From:
Monks Orchard Residents' Association
Planning

Reference: 19/00783/FUL
Application Received: Tue 19 Feb 2019
Application Validated: Tue 19 Feb 2019
Address: 32 Woodmere Avenue Croydon CR0 7PB
Proposal: Demolition of the existing property and the erection of a replacement detached two storey building with accommodation in the roof-space, comprising 7 self-contained flats (2 x 1 bedroom, 3 x 2 bedroom and 2 x 3 bedroom) with 5 off street car parking spaces, bike store, integrated refuse store and site access.
Status: Awaiting decision
Case Officer: Robert Lester
Consultation Close: Sun 24 Mar 2019
Deadline determination: Tue 16 Apr 2019

On behalf of our members and local residents we object to the above-mentioned planning application development proposal on the following grounds. We only object when proposals do not comply with current adopted planning policies which are designed to minimise overdevelopment and retain the local character within acceptable constraints. **The type face with green background are current adopted Planning Policies.**

Fig 8 – Refuse and Recycling Facilities with Access Route

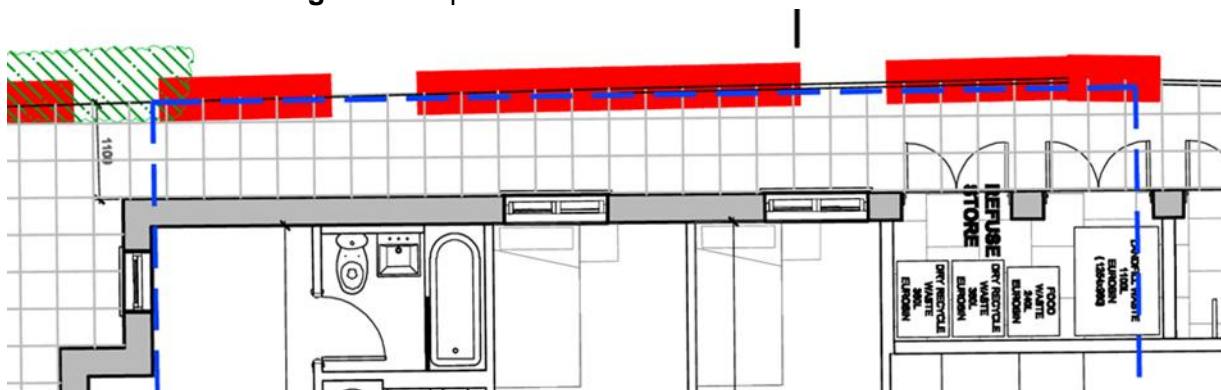
It is understood that there must be a minimum of **150mm clearance** around and between each bin within a storage area. Where there is more than **one bin** within a storage area, there must be **2m clearance in front of each bin** to enable it to be accessed and safely moved without needing to move any of the other containers. The proposed development does not provide this **2m clearance** in front of the bins to allow safe movement.

It is also understood that the access doors to the bin storage must **not open outward** over a **public footway or road**, and should **not** cause any **obstruction** to other accesses when in an open position. The proposed development Refuse Storage doors **DO open outwards** and **DO obstruct access to the Bike sheds** further along the access pathway.

Furthermore, it is understood that all doors and alleys must be at least **2m wide** to allow for safe manoeuvring of bins. The access pathway at the Refuse Store is only **≈1.3m** and this pathway is tapered to **1m** wide at the South East Corner of the building and therefore **Non- Compliant** to this requirement. It should also be clear of any rainwater down pipes and gully's, but these rainwater pipes and gulleys are not shown on the provided plans or documentation. Also, the opened doors to the **Refuse Bins** block the pathway for the operative to move the bins out from the storage area to the refuse vehicle, again in **contravention to the guidance** provided.

The bin storage areas must be located within a specified minimum distance of a point where the collection vehicle can safely stop for loading. The maximum distances that operatives should be required to wheel containers, measured from the furthest point within the storage/collection area to the loading position at the back of the vehicle, should be **no more than 20 metres**. Whereas the distance as measured from the supplied drawing is approximately **30metres**.

It is understood that a water supply, with standard tap fittings be available to the bin storage area to enable washing down of the bins, walls and floor. This requirement is not shown on the plans.
